CITY OF VANCOUVER  
COMMUNITY SERVICES GROUP

DEVELOPMENT PERMIT STAFF COMMITTEE REPORT  
AUGUST 24, 2011

1460 BUTE STREET (COMPLETE APPLICATION)  
DE414843 - ZONE RM-5A

# ROOFTOP LANDSCAPE CONCEPT 1460 BUTE AT BEACH

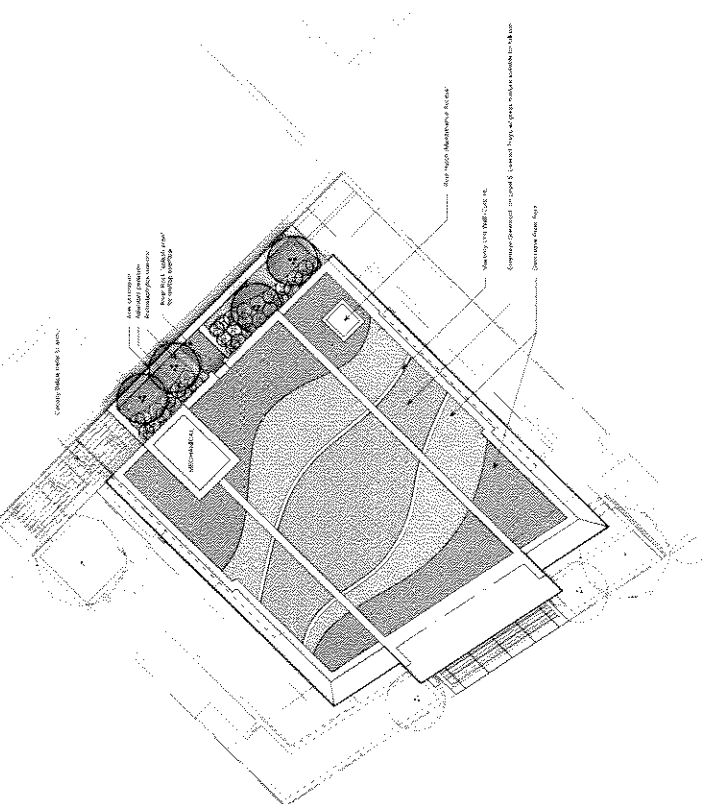
- A.1.19 provision of a section/elevation detail (at a minimum scale of ½"=1'-0") illustrating the Vine Maple tree planter on the roof deck;

**Note to Applicant:** The illustration should confirm the planter depth and location of slab, context, and method of irrigation. Planter depth should meet the latest edition of BC Landscape Standard.

# LEVEL 1 PLANTING PLAN 1460 BUTE AT BEACH

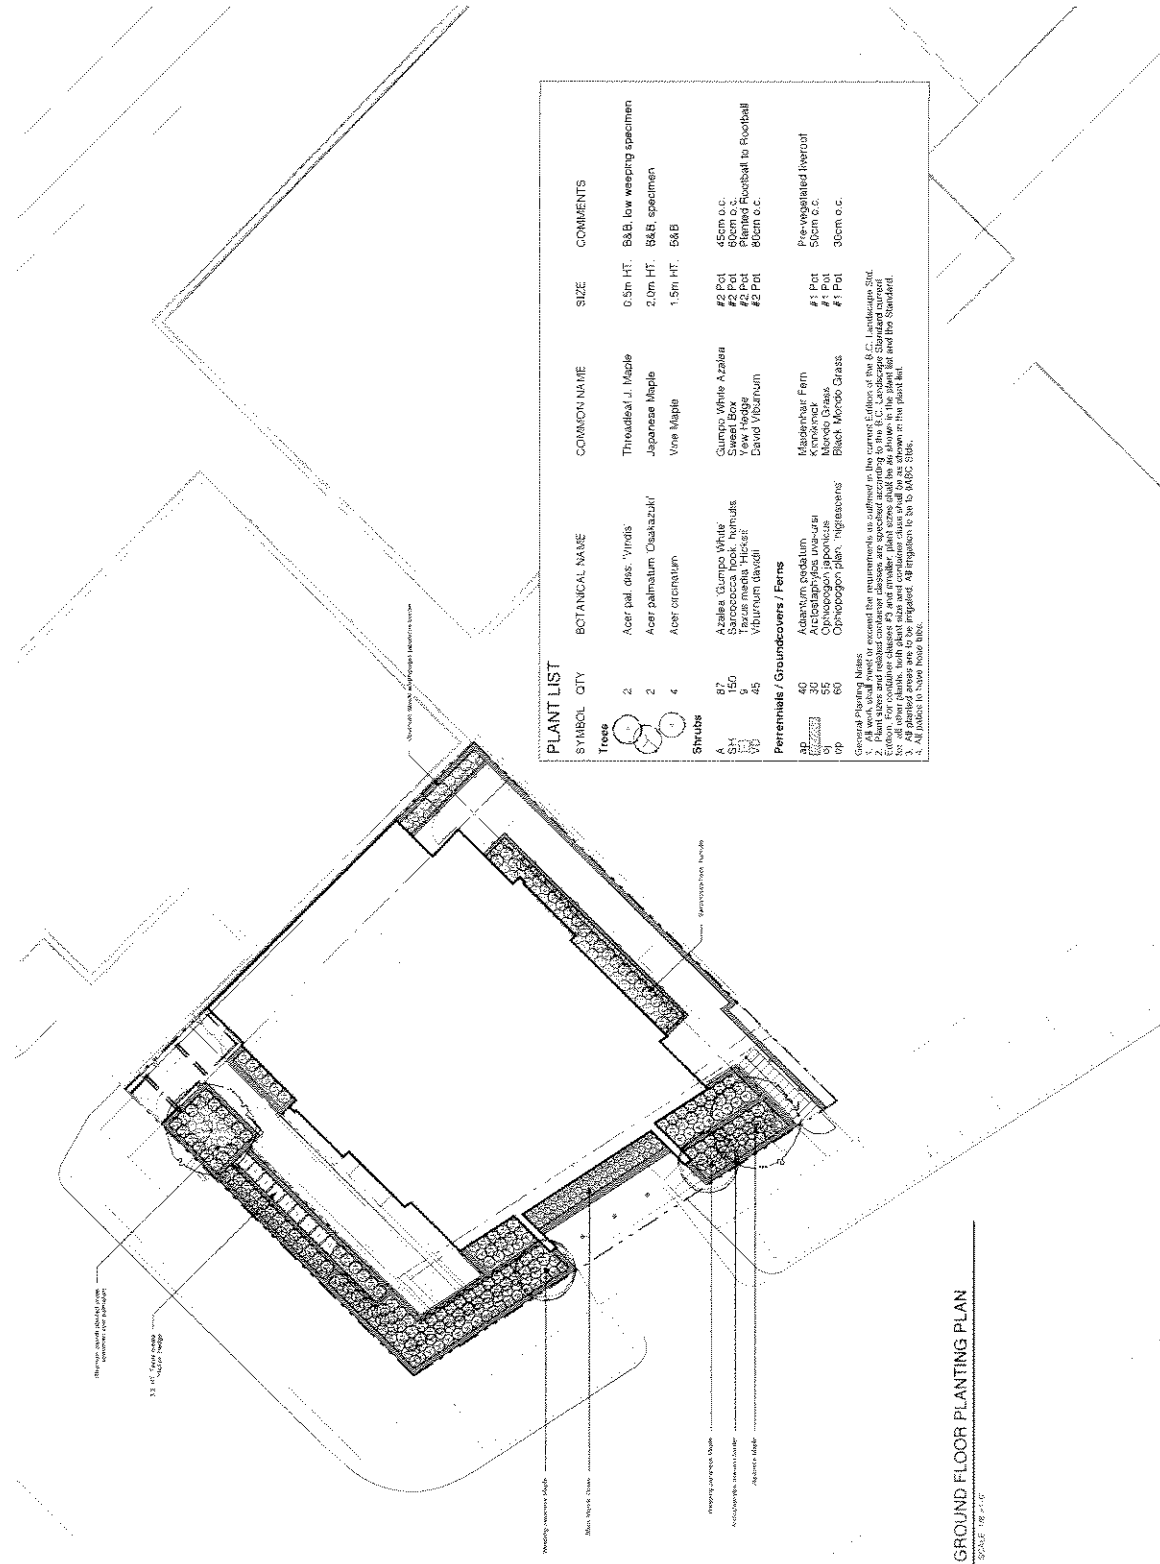
**Note to Applicant:** Information on Sheet No. A2.02 - Level 1 Plan and Sheet No. L01 of the Landscape Plan does not match. Submission of a separate application is required for bicycle racks on City property.
